> Application of Orange County-Poughkeepsie Limited Partnership d/b/a Verizon Wireless -110 Howland Avenue (Howland Micro Site)

The purpose of this letter is to provide responses to the comments of the City of Beacon Telecommunications Consultant, HDR in connection with the above-referenced application, which comments were provided to us on Friday, March 1, 2019. Set forth below are the HDR comments in its entirety followed by our responses.

PROJECT NO.: 20161509173 SITE NAME: HOWLAND MICRO

Z-2

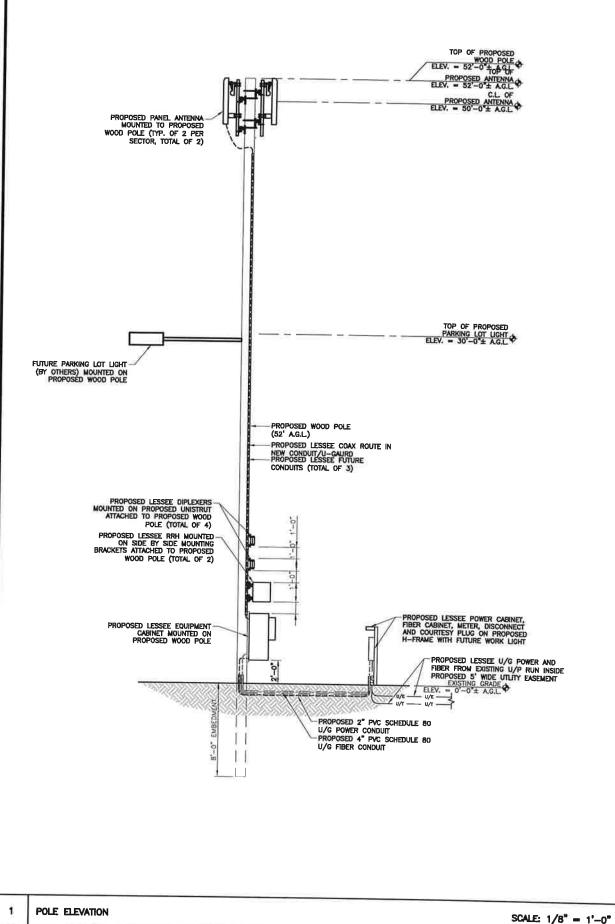
The Drawing set (e.g., DWG Z-1) should be updated to show all property lines for the subject site, including the back property line. HDR's site visit noted a drainage swale on the slope behind the parking area with a sign marked "Private Property". It is requested that Verizon confirm if any subgrade utilities or easements may be associated with this feature.

A copy of the revised plans is enclosed.

Proposed (Mt. Beacon Gamma Off) 2100MHz Best Server -105dBm RSRP

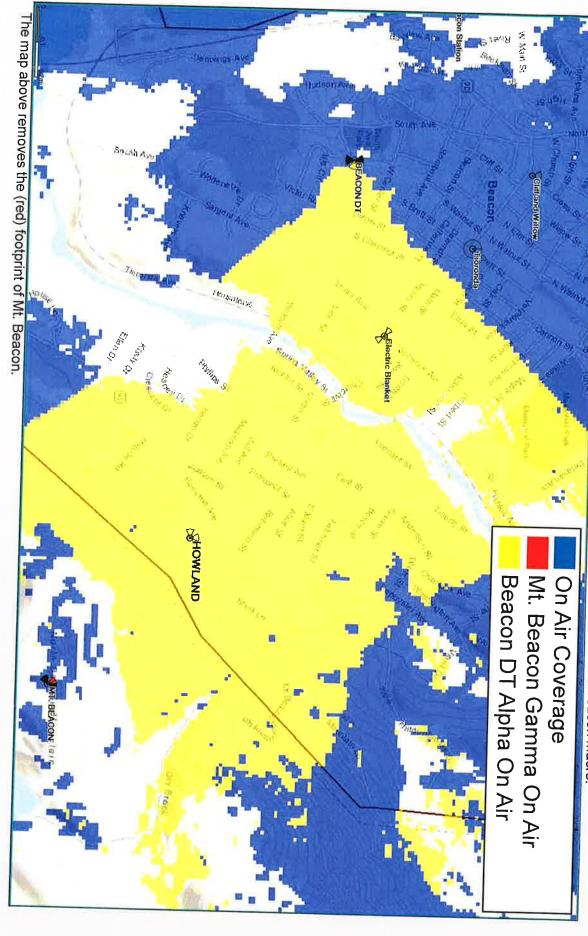
In the Engineering Necessity Case – "Howland Micro", please describe the reason for differences between:

Page 19 – The Green "proposed coverage" on the Map entitled, Proposed (Mt. Beacon Gamma Off) 2100MHz Best Server -95dBm RSRP and Page 22 – The Yellow "proposed coverage" around the Howland site as depicted on the Map entitled, Proposed 2100 MHz Coverage.

There were some mis-labeled coverage thresholds in the title of the slides in the Radio Frequency Justification. This was an oversight and has been corrected in the revised analysis enclosed herewith.

RF Justification Summary

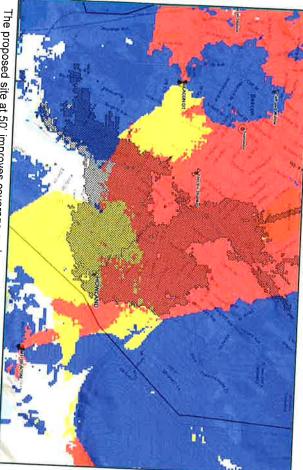
An alternate height coverage map / capacity statement is requested, evaluating the feasibility of an antenna centerline height of 40 ft agl (vs. the proposed 50 ft antenna centerline height). The same frequencies (2100 MHz) and RF criteria (-95 dBm) as used in the prior Engineering Necessity Case — "Howland Micro" should be used. This supplemental information is requested to justify the proposed pole height, and the differential in coverage + capacity afforded to the area.

A revised Radio Frequency Justification report has been prepared and enclosed, which includes a slide showing the coverage associated with a 40' utility pole.
